Chapter 3

Modifications to the Draft EIR

This chapter of the document addresses modifications to the Draft EIR for the Waterfront project (proposed project) in the City of Redondo Beach. It presents all revisions related to public comments, as determined necessary by the lead agency, and any revisions to supporting documentation. Although all chapters/section of the Draft EIR are included in Section 3.2, only the following areas of the document included modifications and clarifications:

Figure 1
Peak Hour Traffic Volumes and Lane Configurations
Existing Conditions

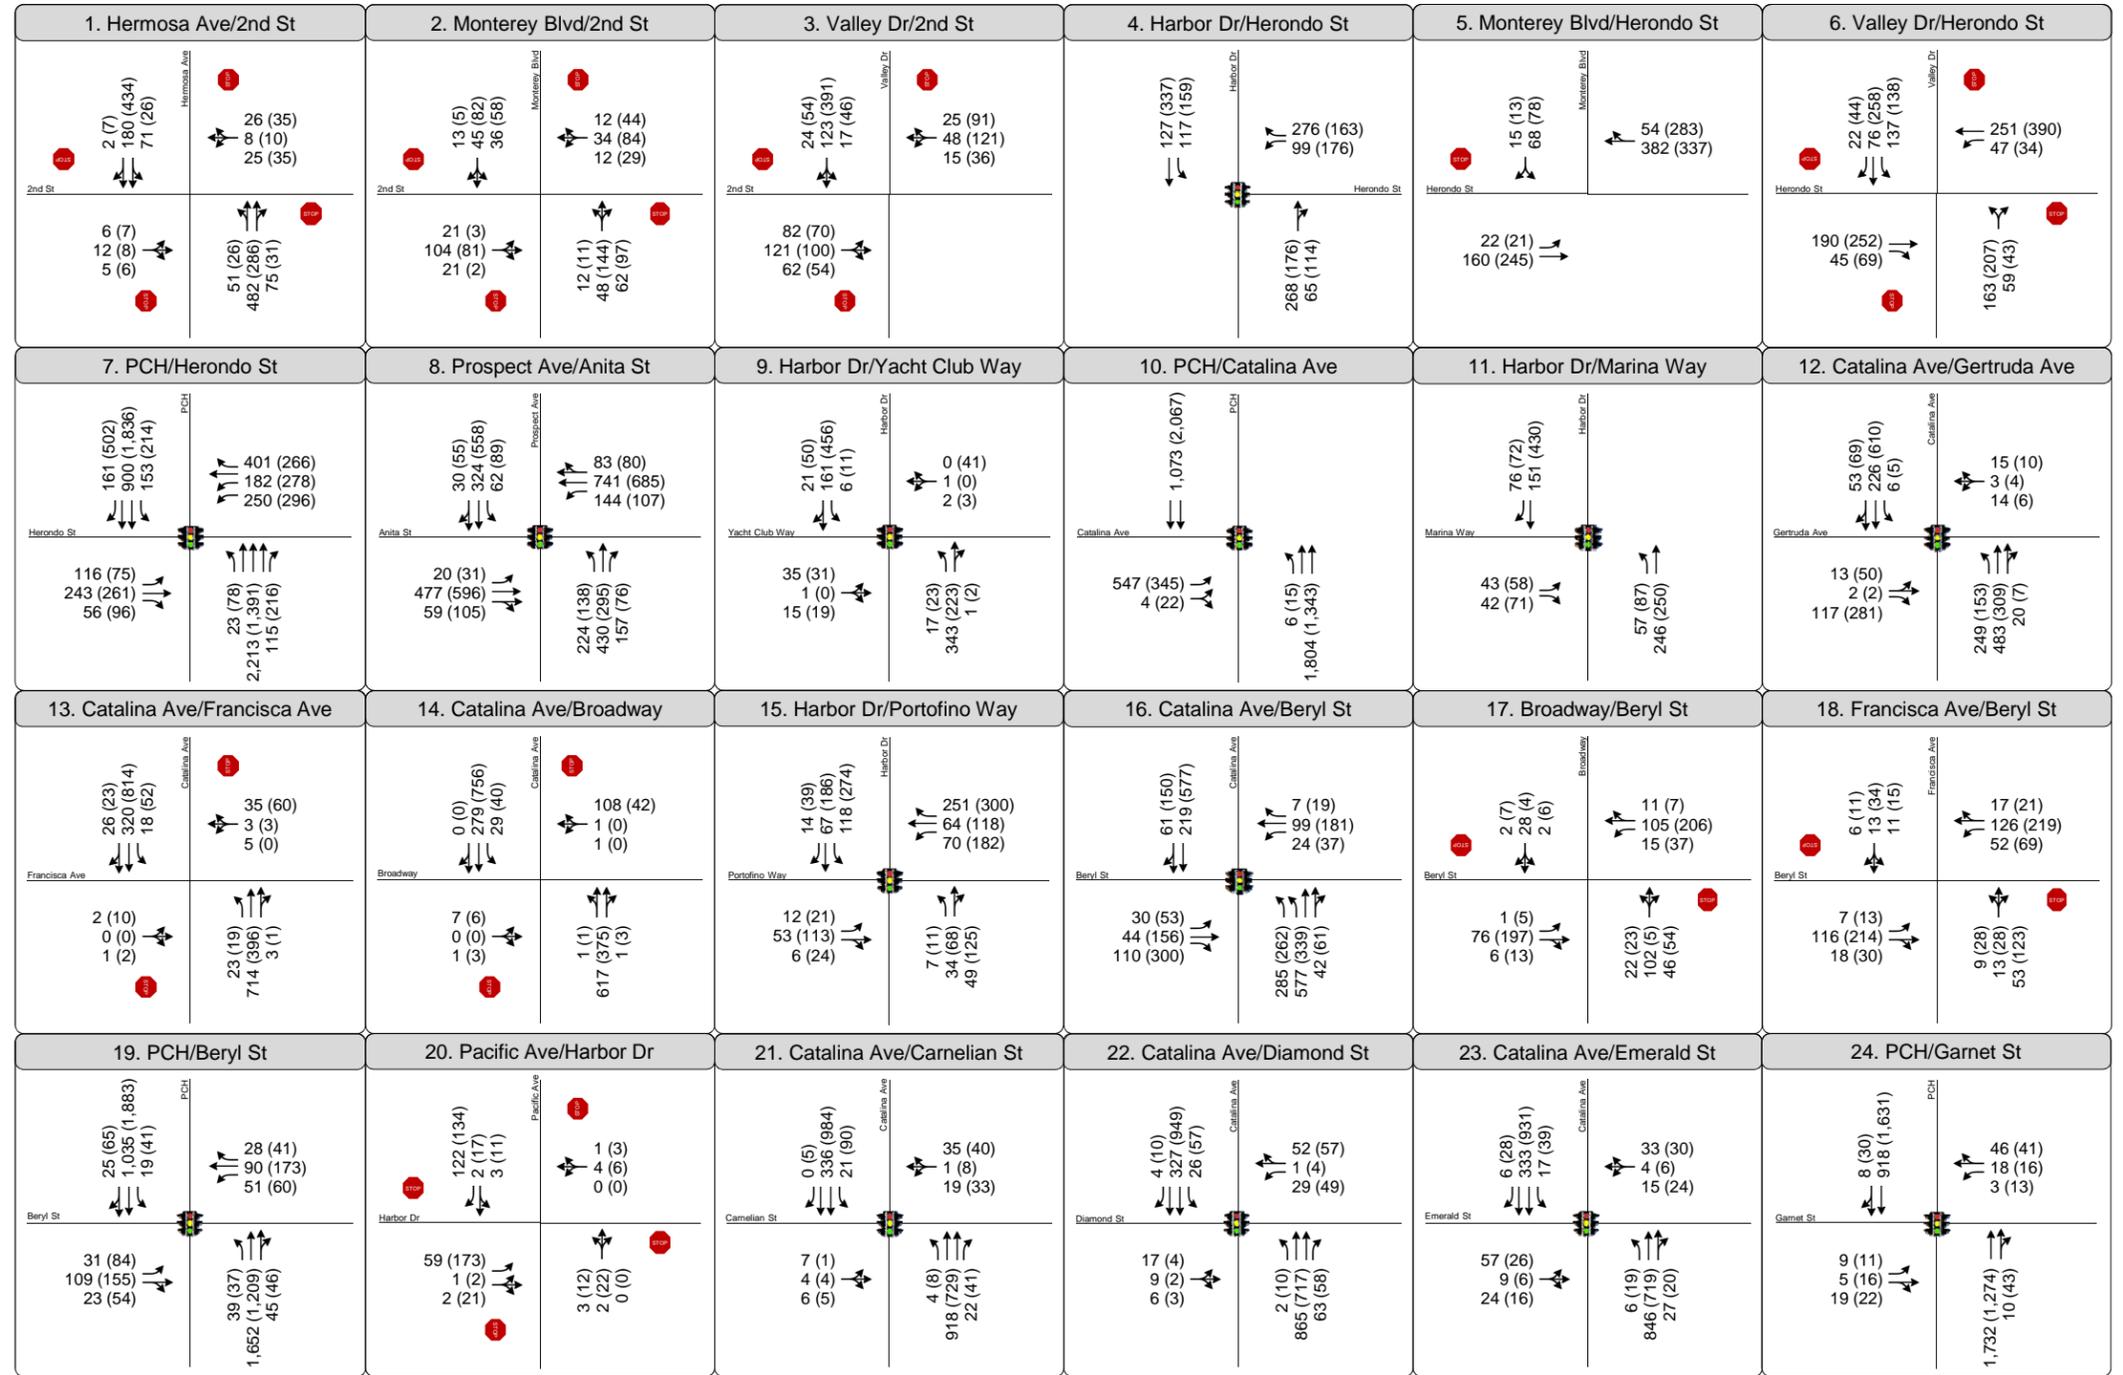
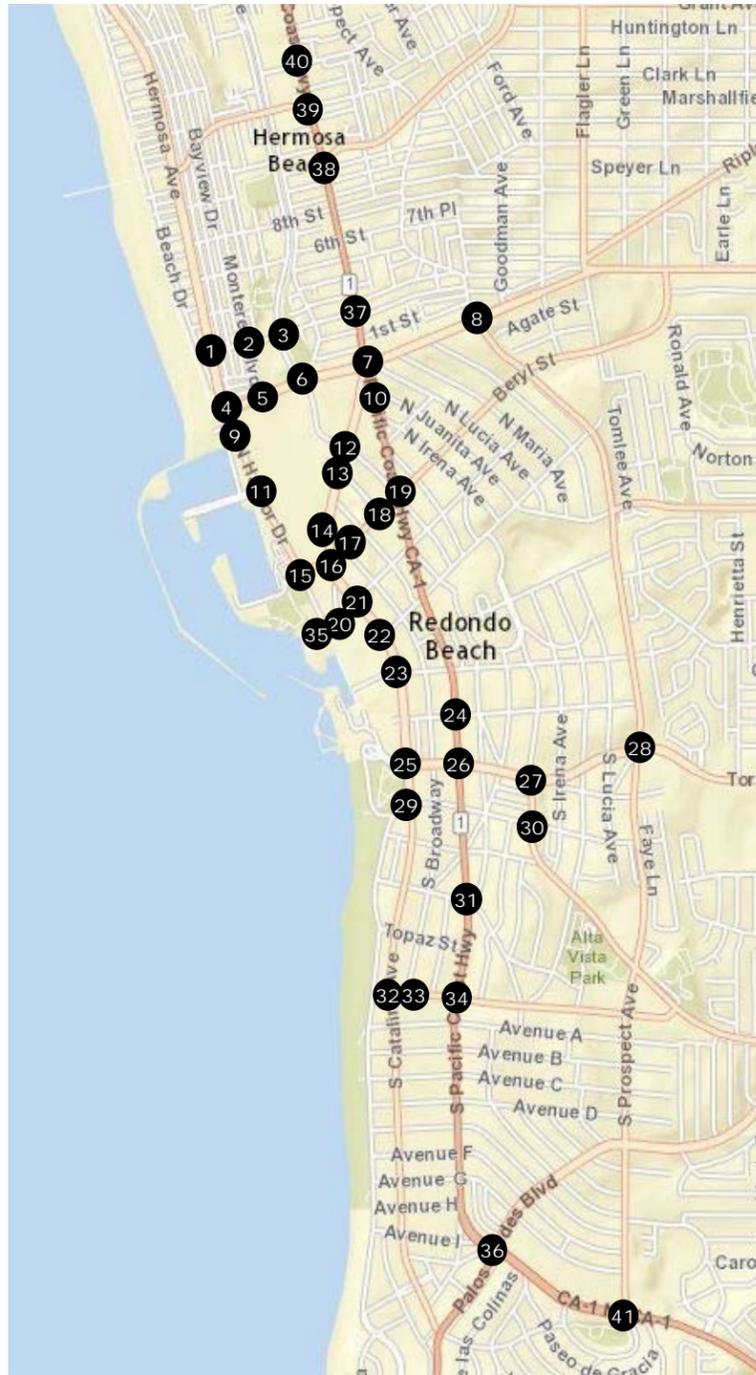
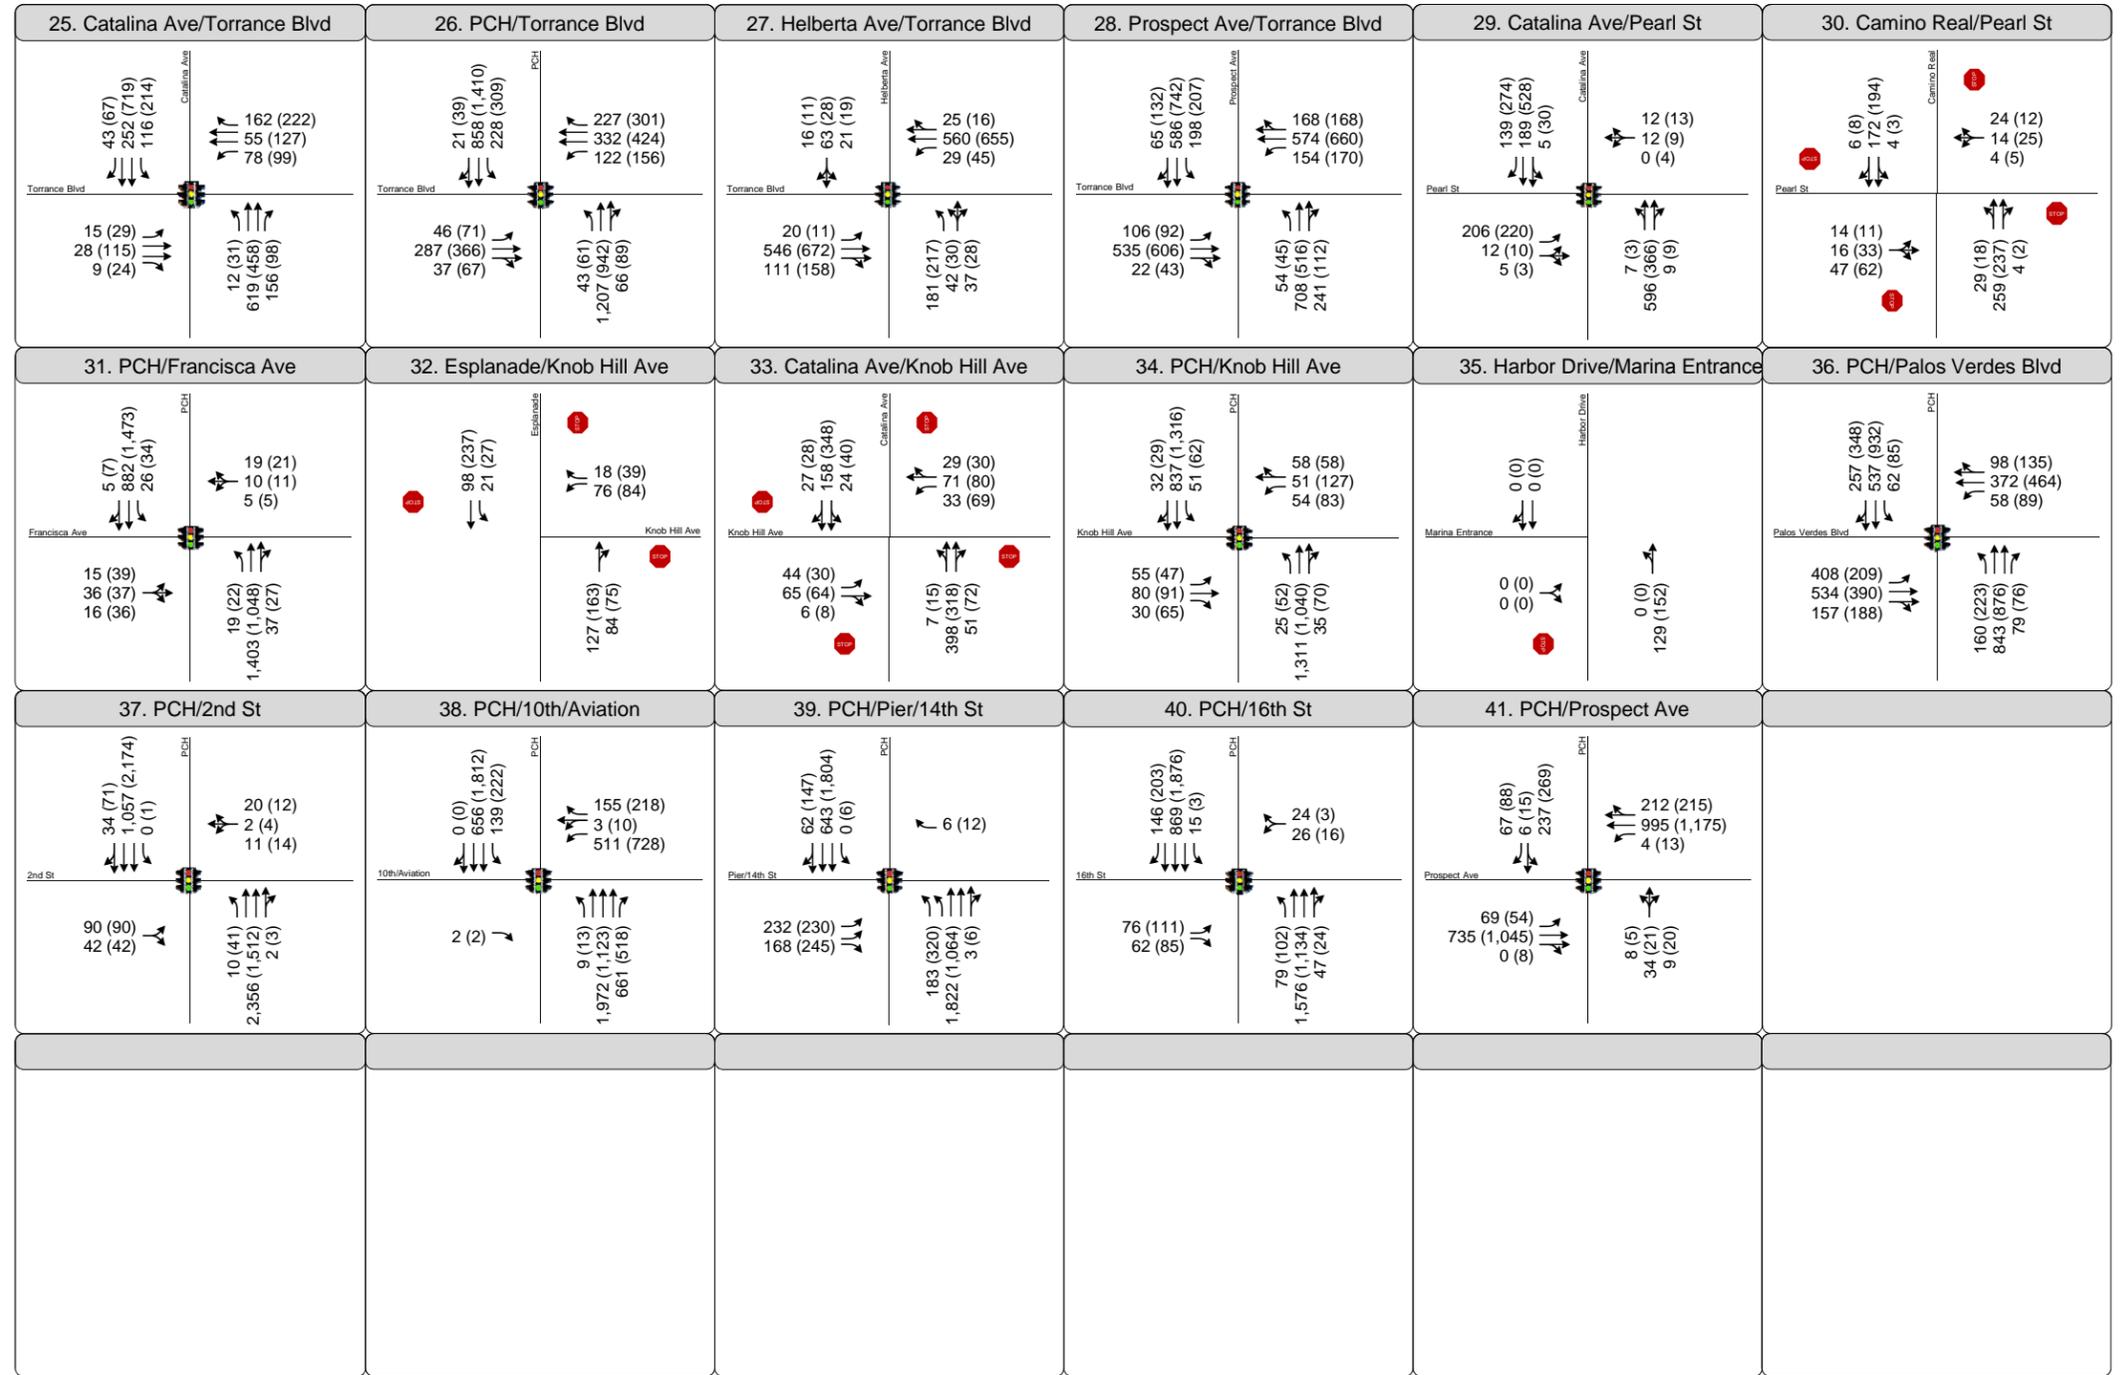
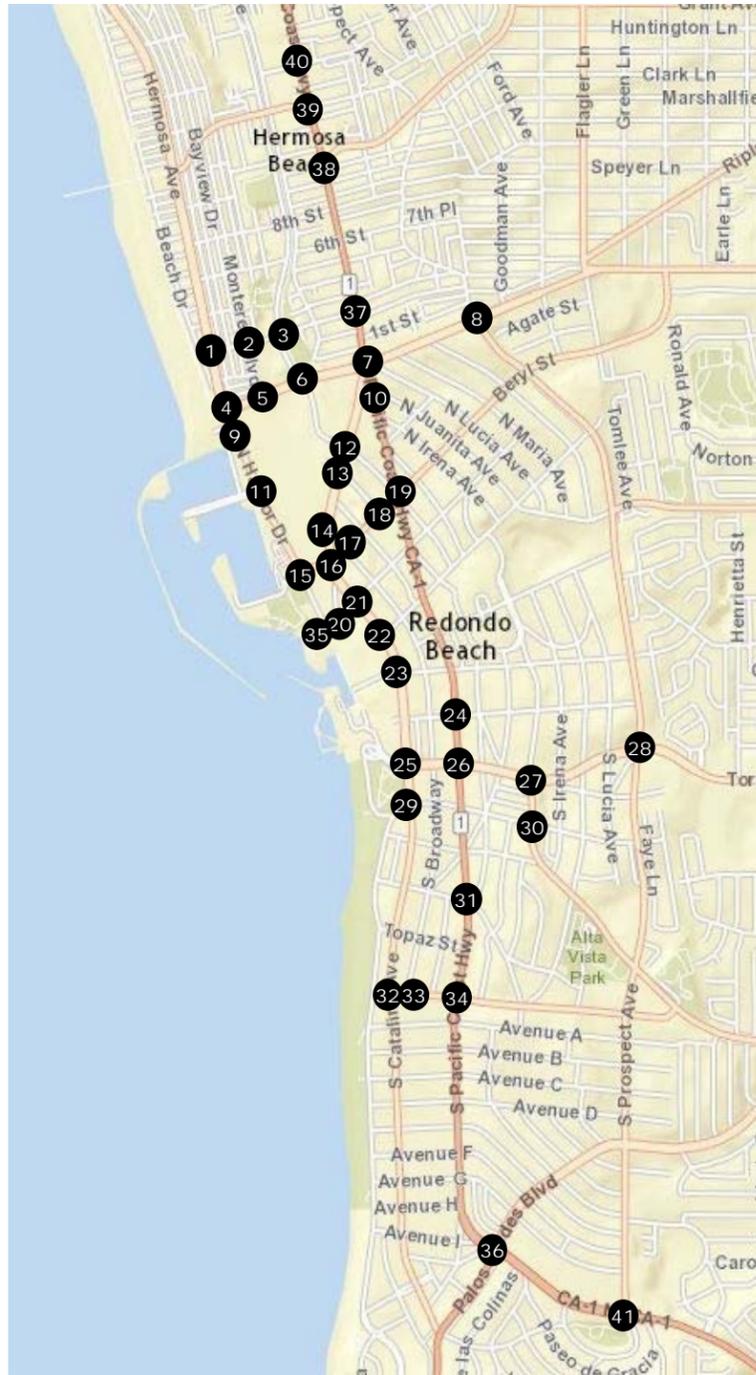
Labeling on the Appendix X-2 figures was updated for clarity purposes. Replace all of Appendix X-2 figures with the following:
